# **Comment Agenda**

## **162 cable assembly**

### **162A-D Annexes**

**Chris DiMinico**  
**MC Communications/PHY-SI LLC/Panduit**  
[cdiminico@ieee.org](mailto:cdiminico@ieee.org)

# CA DC RL – 71\*, 181, 147, 74,

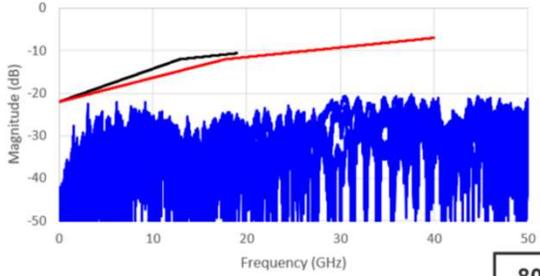
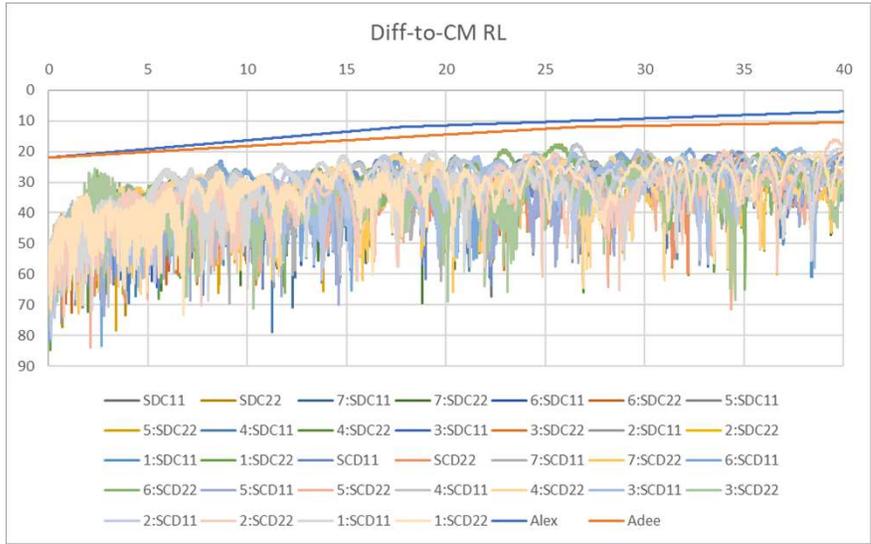
**802.3ck proposal:**  
 $\left(22 - \frac{15}{26.56}f\right) \text{ dB} \quad 0.05 \text{ GHz} \leq f < 17.7 \text{ GHz}$   
 $\left(16 - \frac{6}{26.56}f\right) \text{ dB} \quad 17.7 \text{ GHz} \leq f \leq 40 \text{ GHz}$

#71 haser\_3ck\_adhoc\_02\_061720.pdf

## common to differential mode RL proposals

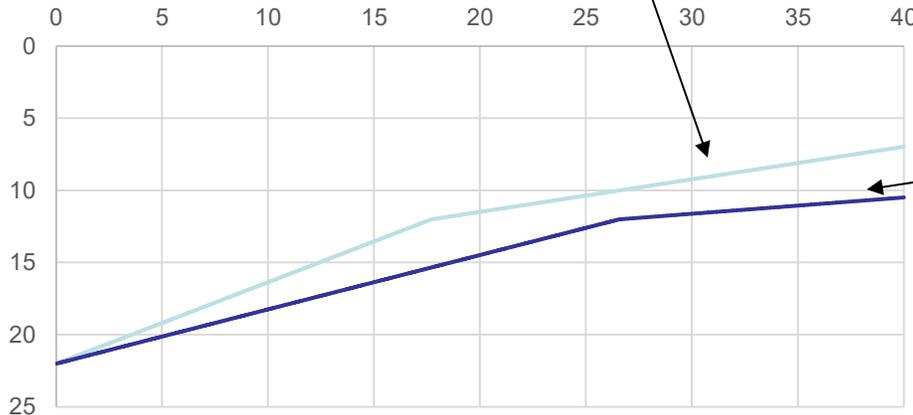
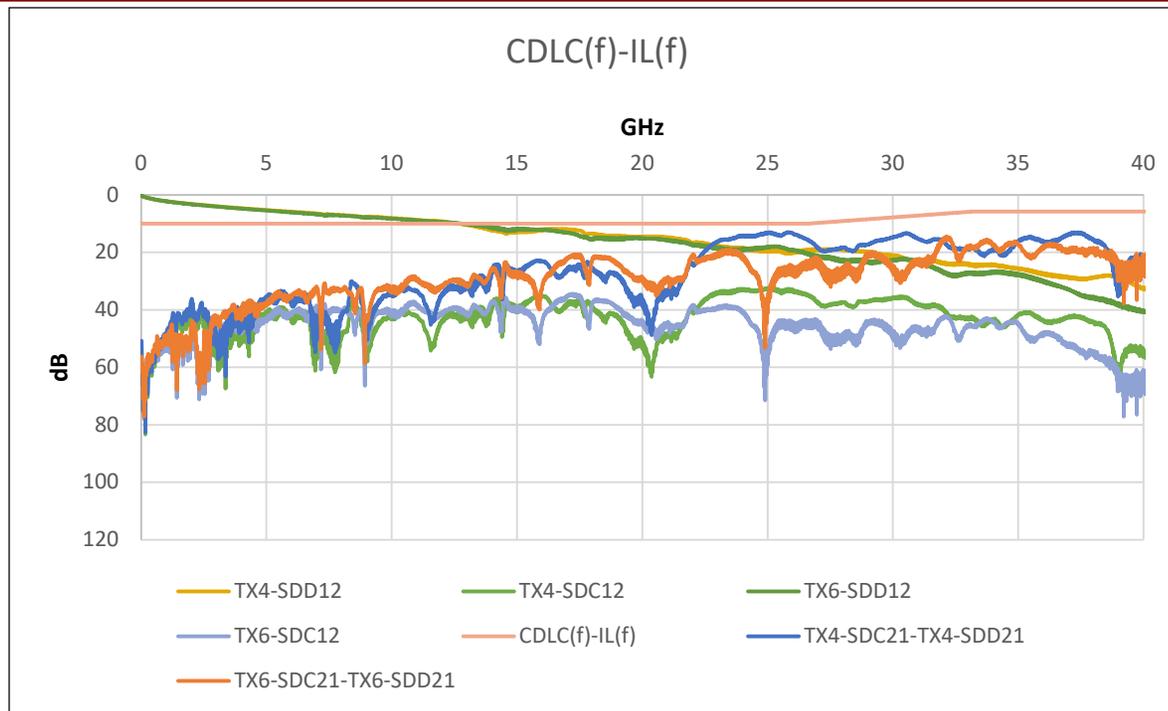
Alex # 71    Adee - #147

#147 ---CDRL(f) ≥  
 $22 - 10 * f / f_N, 0.01 \leq f \leq f_N$   
 $15 - 3 * f / f_N, f_N < f < 40$   
 Where  
 $f_N = 26.5625$  is the Nyquist frequency in GHz  
 f is the frequency in GHz

# CA CC RL – 73\*,181,76

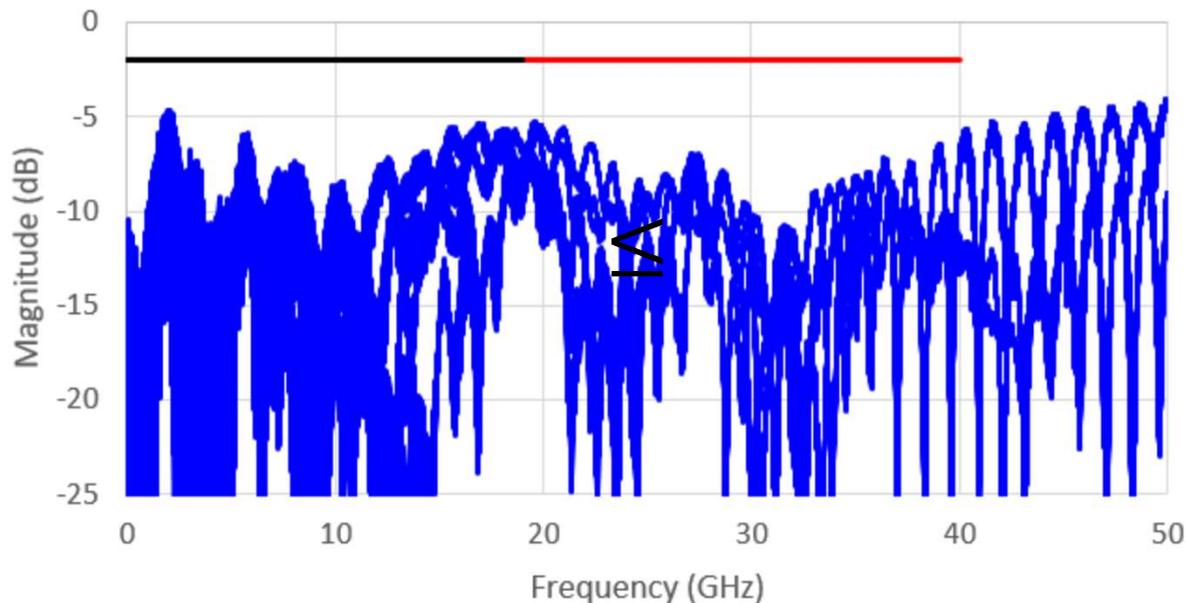
**802.3ck proposal:** 2 dB  $0.05 \text{ GHz} \leq f < 40 \text{ GHz}$

Figure 92A-1—Insertion Loss Tx or Rx PCB max and min

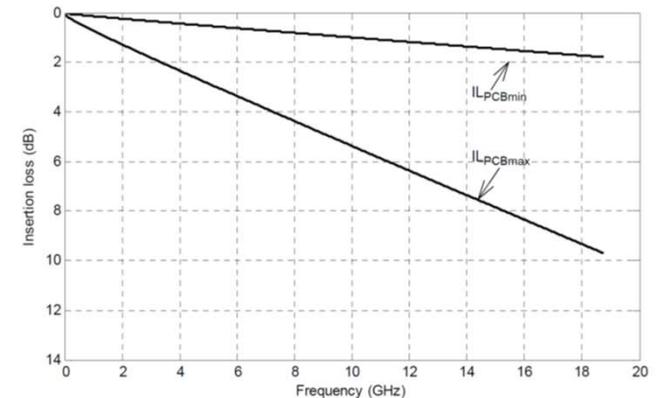
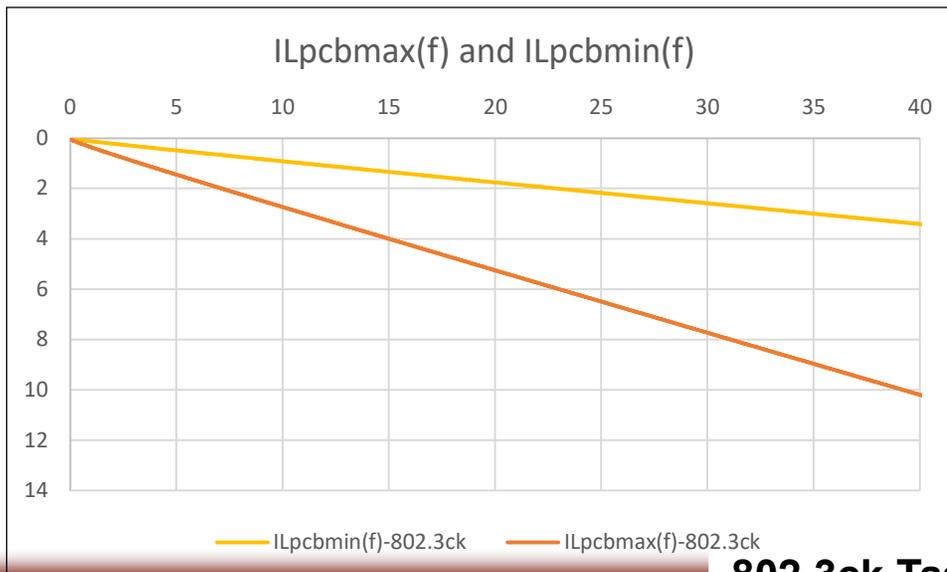
Note that the recommended maximum insertion loss allocation for the transmitter or receiver differential controlled impedance printed circuit boards with allowances for ball grid array (BGA) footprint and host connector footprints is 6.875 dB at 26.56 GHz and the recommended minimum insertion loss allocation for the transmitter or receiver differential controlled impedance printed circuit boards is 2.3 dB at 26.56 GHz. The recommended maximum insertion loss allocation for the transmitter or receiver differential controlled impedance printed circuit boards is consistent with the insertion loss from TP0 to TP2 or TP3 to TP5 given in **TBD** and an assumed mated connector loss of 1.6 dB.

Editorial license update Annex reference to 162.11.2 ILCamin

$$IL_{pcbmax}(f_{ghz}) = 0.0176 + 0.1082 * \text{SQRT}(f_{ghz}) + 0.2372 * f_{ghz}$$

$$IL_{pcbmin}(f) = 0.0059 + 0.0361 * \text{SQRT}(f_{ghz}) + 0.0794 * f_{ghz}$$

# #86,87 - MTF Differential Return Loss

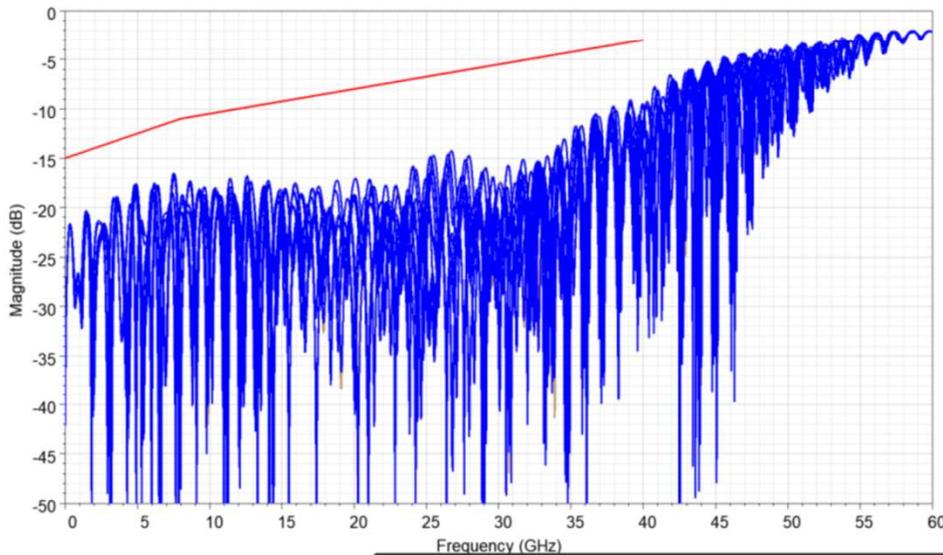
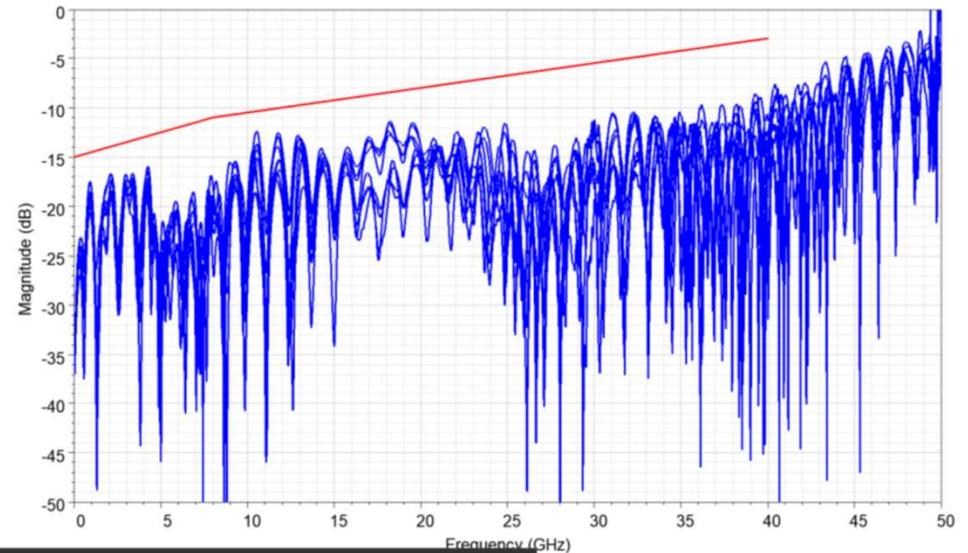
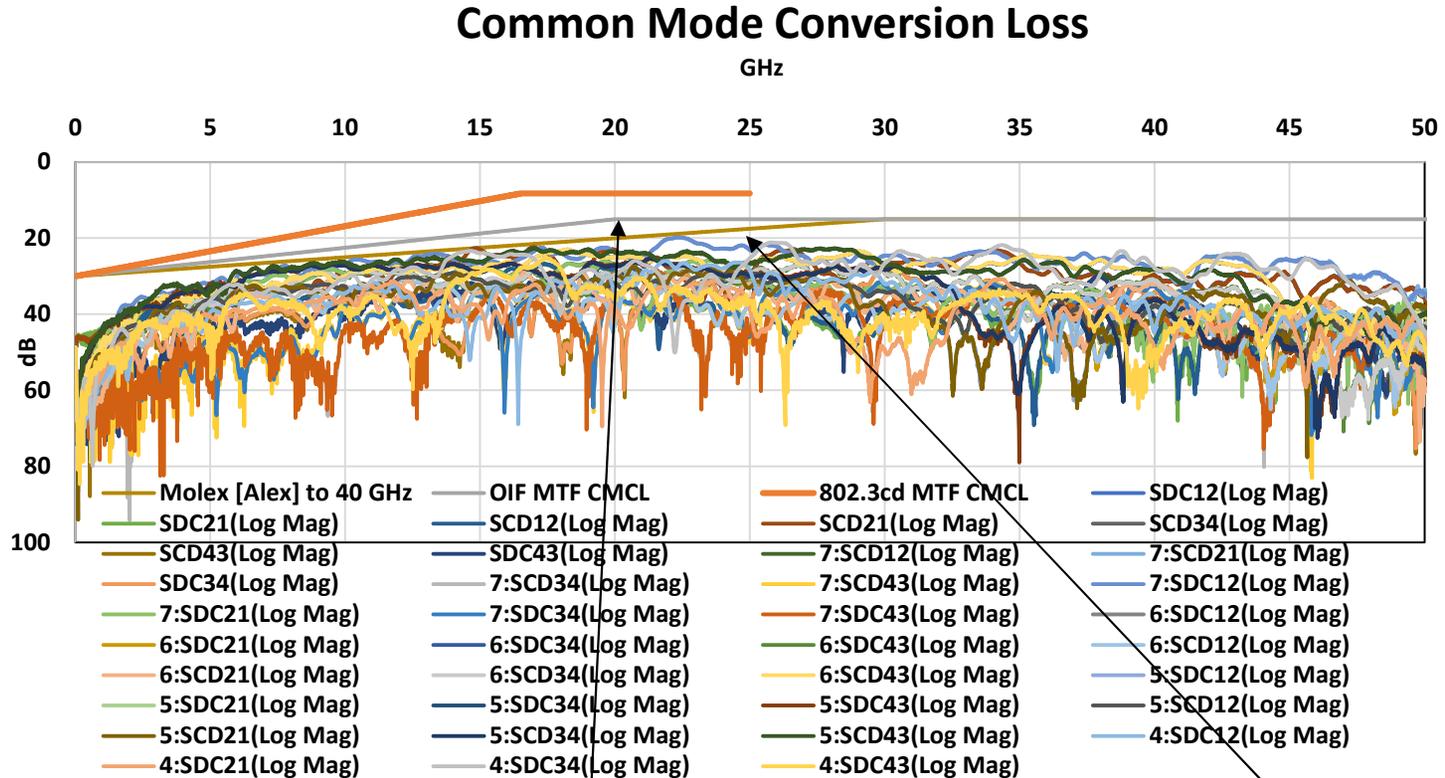
#86,#87 - 162B.1.3.2 Mated test fixtures - **RL (TBD)** - Change from 0.01 GHz  $\leq f_{\text{GHz}} \leq 50$  GHz to **0.05 GHz  $\leq f_{\text{GHz}} \leq 40$  GHz** and update figure.

Proposal:  $15 - 0.5f$   $f < 8 \text{ GHz}$   
 $13 - 0.25f$   $8 \text{ GHz} \leq f \leq 40 \text{ GHz}$

# #88,#89 -162B.1.3.4 Mated test fixtures - CMCIL

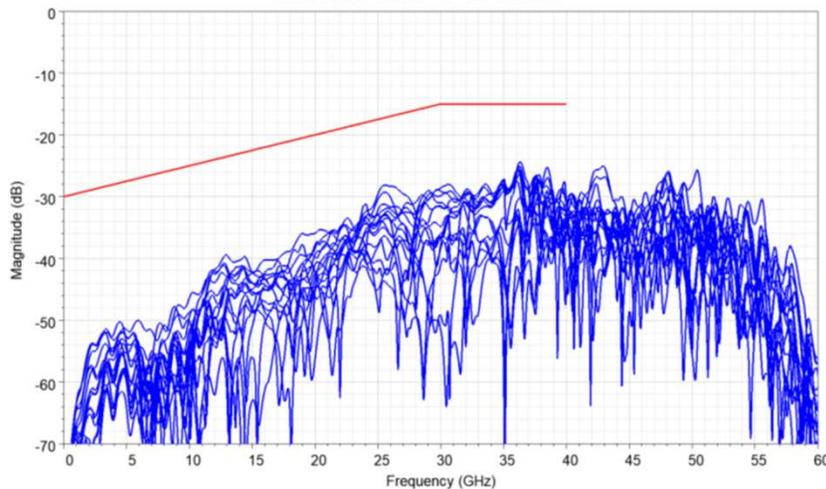
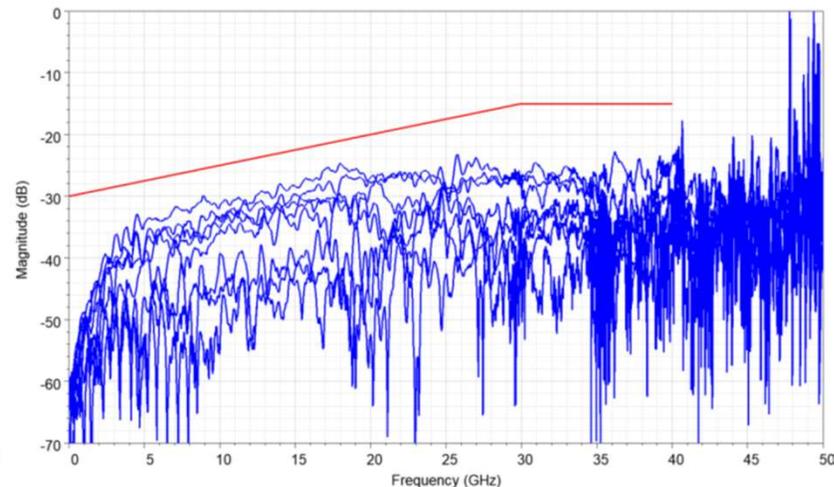
#88,#89 - 162B.1.3.4 Mated test fixtures - **CMCIL (TBD)** - Change from  $0.01 \text{ GHz} \leq f_{\text{GHz}} \leq 50 \text{ GHz}$  to  $0.05 \text{ GHz} \leq f_{\text{GHz}} \leq 40 \text{ GHz}$  and update figure.

Proposal:	$30 - 0.5f$	$f < 30 \text{ GHz}$
	15	$30 \text{ GHz} \leq f \leq 40 \text{ GHz}$

# IL Frequency range Max – 79, 80, 81,82

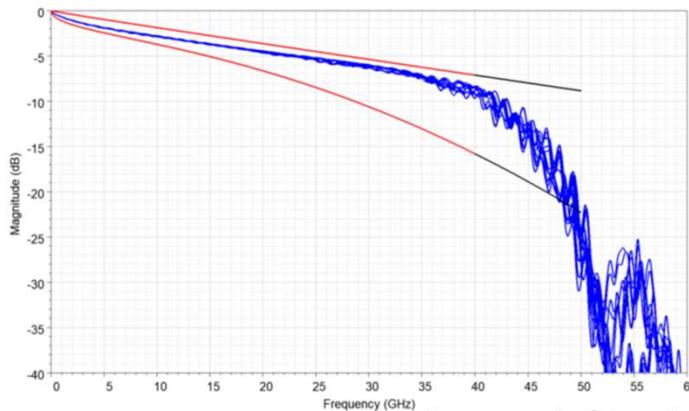
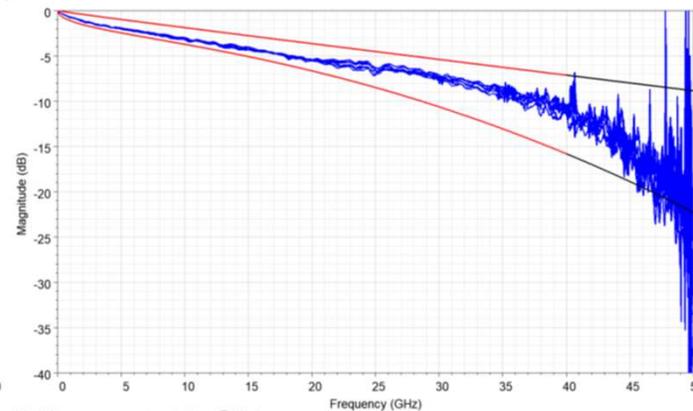
#79- 162B.1.1.1 Reference IL - Change from  $0.01 \text{ GHz} \leq f_{\text{GHz}} \leq 50 \text{ GHz}$  to  $0.05 \text{ GHz} \leq f_{\text{GHz}} \leq 40 \text{ GHz}$  and update figure.

#80- 162B.1.2.1 Cable assembly test fixture reference IL - Change from  $0.01 \text{ GHz} \leq f_{\text{GHz}} \leq 50 \text{ GHz}$  to  $0.05 \text{ GHz} \leq f_{\text{GHz}} \leq 40 \text{ GHz}$  and update figure.

#81,#82- 162B.1.3.1 Mated test fixtures max and min IL - Change from  $0.01 \text{ GHz} \leq f_{\text{GHz}} \leq 50 \text{ GHz}$  to  $0.05 \text{ GHz} \leq f_{\text{GHz}} \leq 40 \text{ GHz}$  and update figure.

Proposal: Stop limit lines at 40 GHz
